Report: 1547 TAB REPORT
Function: Test, Adjust, & Balance
Date: 07/24/2025
Completed By: National TAB

PROJECT
07-21-25 WHATABURGER #1547 DULUTH,
GA

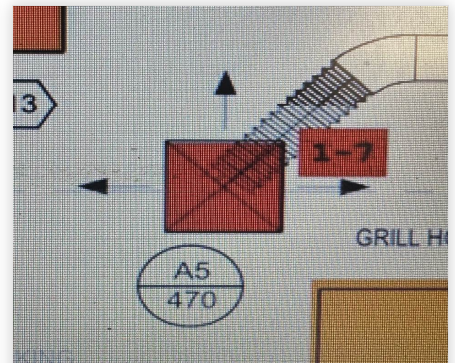
Issue Name : DIFFUSER 1-7 IS THE WRONG TYPE
Description : The diffuser serving over hood one is supposed to blow in three directions, with the side blowing to the hood blocked off. The installed diffuser is unable to achieve that. The diffuser should be A5, but A4 was installed.
Created By : National TAB **Assigned To :** National TAB - Ben Searles
Status : Open
Priority : Medium **Asset Tag :**
Originated Date : 07/24/2025 - Ben Searles - National TAB

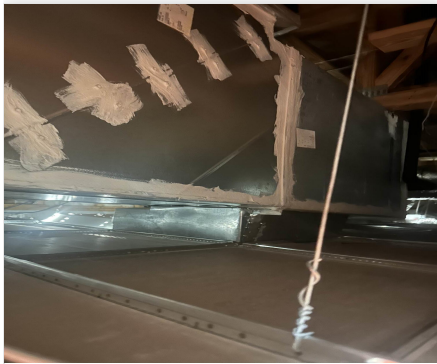
Issue Name : DUCTWORK INSULATION
Description : The supply and return drops for both RTUs are not externally insulated. The return duct is also not internally insulated, and the technician was unable to verify if the supply was internally insulated either.
Created By : National TAB **Assigned To :** National TAB - Ben Searles
Status : Open
Priority : Medium **Asset Tag :**
Originated Date : 07/24/2025 - Ben Searles - National TAB

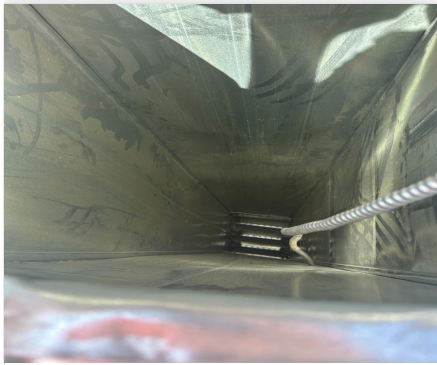
Issue Name : EF INSULATION
Description : The restroom fan's ductwork is not internally or externally insulated.
Created By : National TAB **Assigned To :** National TAB - Ben Searles
Status : Open
Priority : Medium **Asset Tag :**
Originated Date : 07/24/2025 - Ben Searles - National TAB

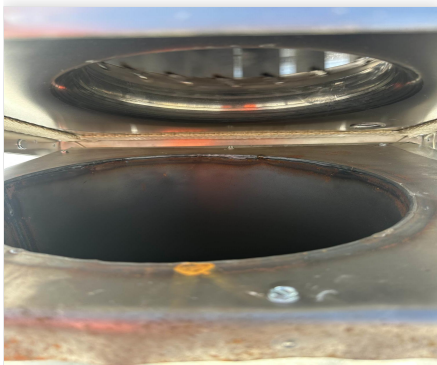
Issue Name : KEF GREASE TRAPS
Description : The grease traps for both kitchen exhaust fans are not installed.
Created By : National TAB **Assigned To :** National TAB - Ben Searles
Status : Open
Priority : Medium **Asset Tag :**
Originated Date : 07/24/2025 - Ben Searles - National TAB
